CERTIFICATE OF APPROPRIATENESS PLACARD

125 N HARRINGTON STREET

CP&L CAR BARN & GARAGE

Raleigh Historic Development Commission – Certificate of Appropriateness (COA) Application

STOREFRONT ELEVATIONS

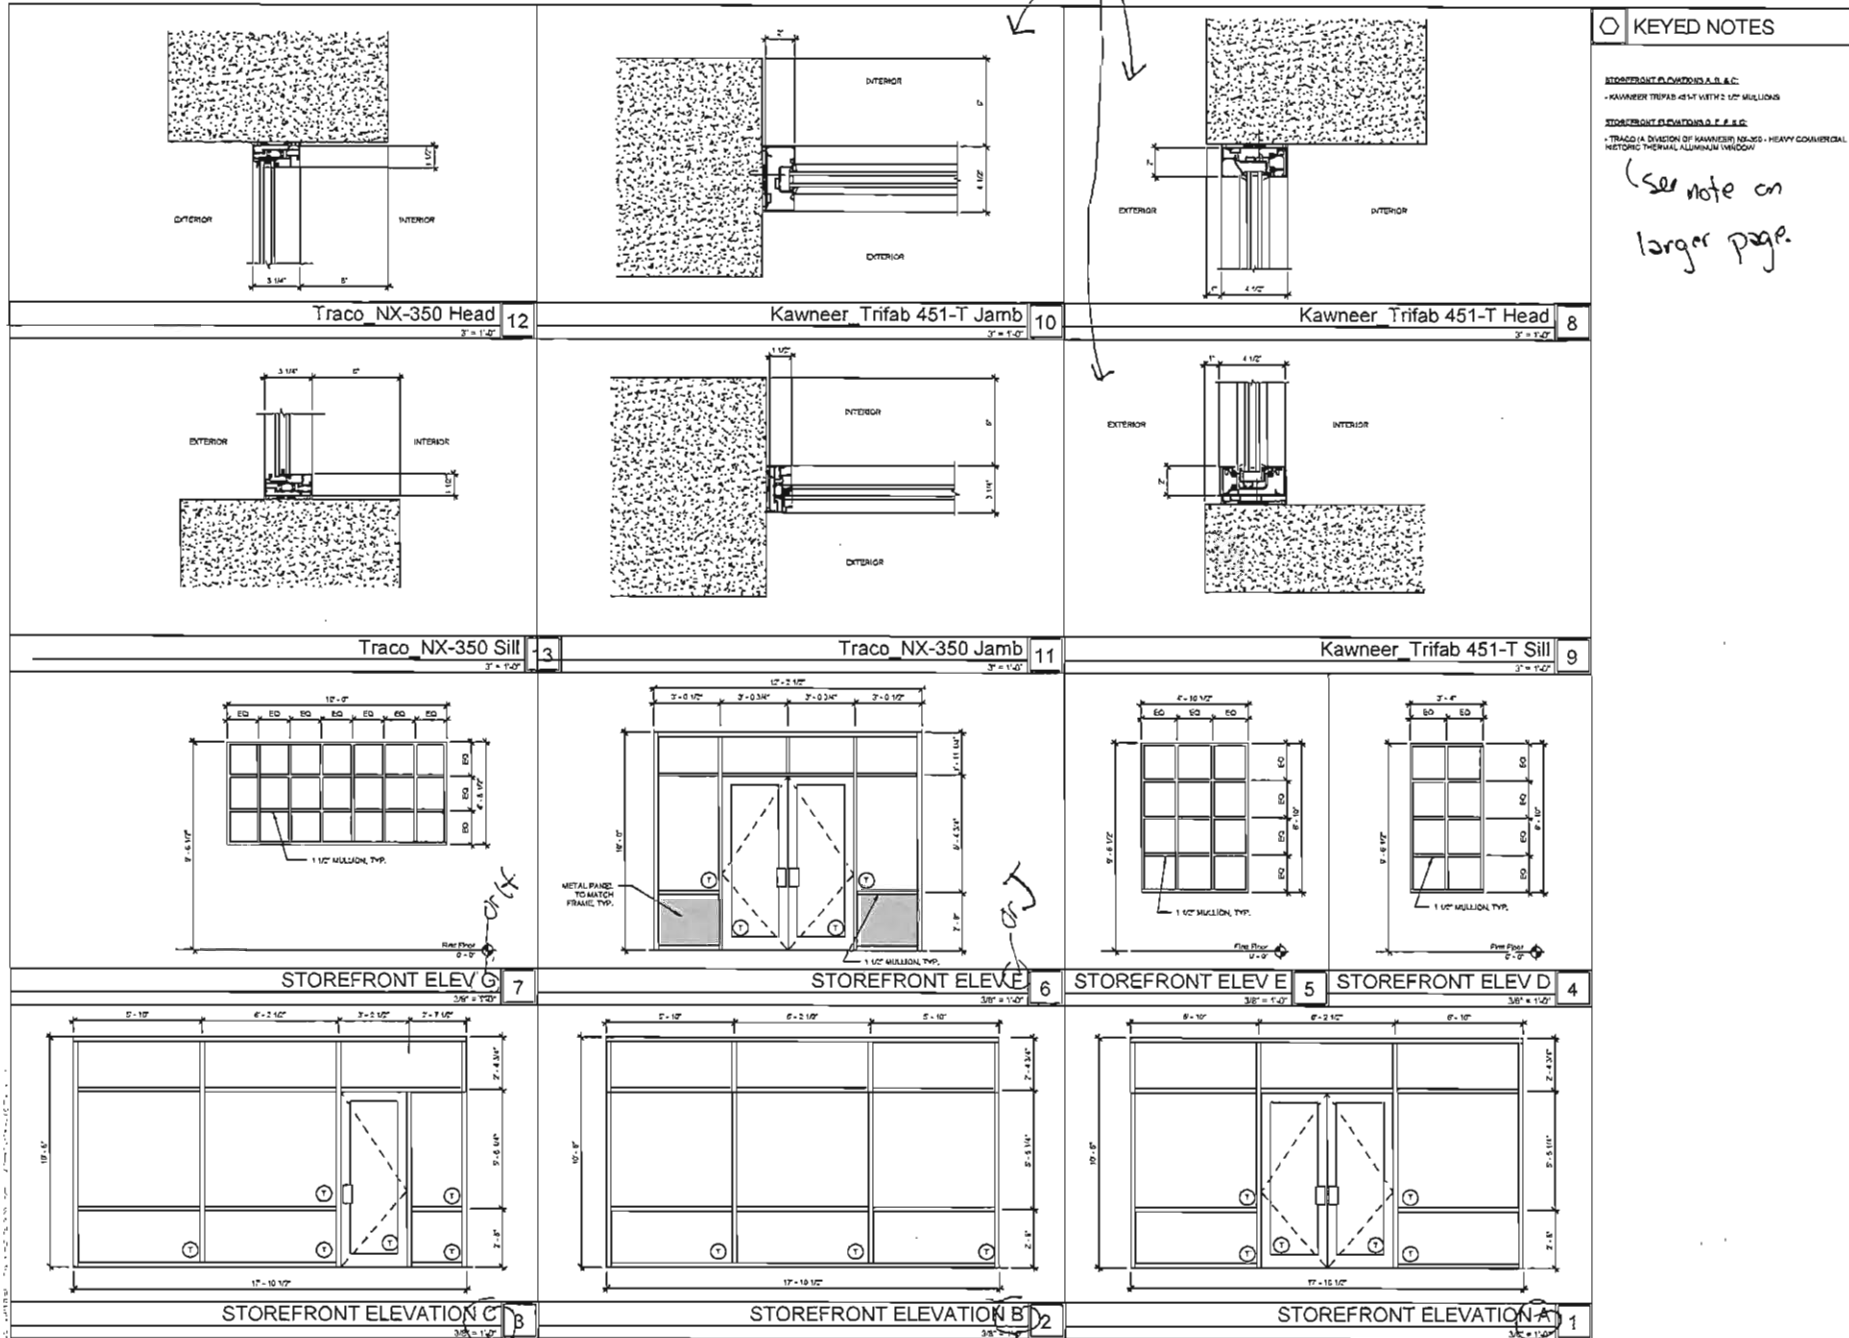
- electronic versions of the drawings; the hard copies are too small to see;
- clarification of which of the details on the Traco spec sheets are applicable to the new windows;
- current photo of the louver location being re-opened;
- current photo of the north elevation window being replaced;
- current photos of the south side of the building;
- mounting details for the new awning (the larger drawings may help – I cannot tell where on the building the hanging rods will attach);
- indication of whether light fixtures are being removed and if new ones are being installed;
- request for removal of exiting signage (likely already removed, but technically needs a COA)

STOREFRONT ELEVATIONS D, E, F, & G:

- TRACO (A DIVISION OF KAWNEER) NX-350 - HEAVY COMMERCIAL HISTORIC THERMAL ALUMINUM WINDOW

TRACO NX-350

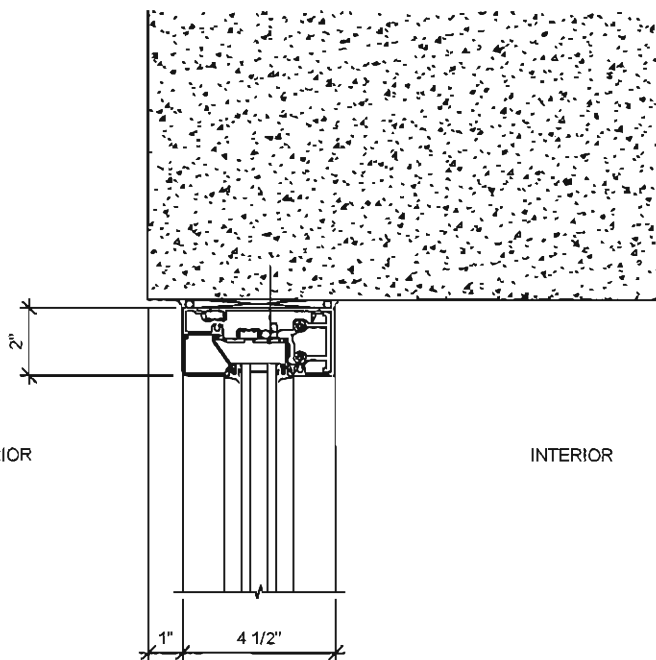
✓ Regarding the window mullion design, the fixed Bevel Frame on page 3 I think looks most like the original windows.

OK

D, E & G will be

per 4/16/14
email

Super Lumideck

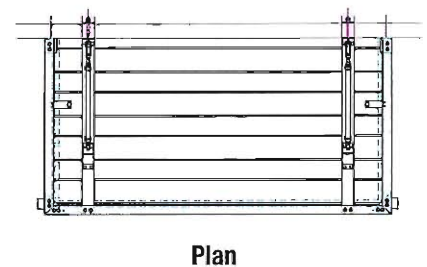
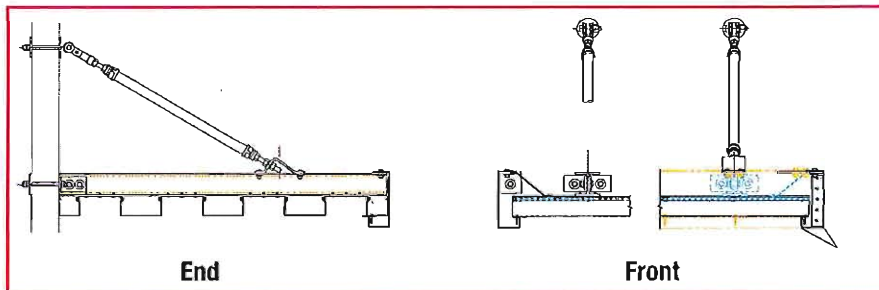
✓ Regarding the metal canopy, I have included the spec sheet again and highlighted which details we would be using. Let me know if that helps.

4/10/14 email
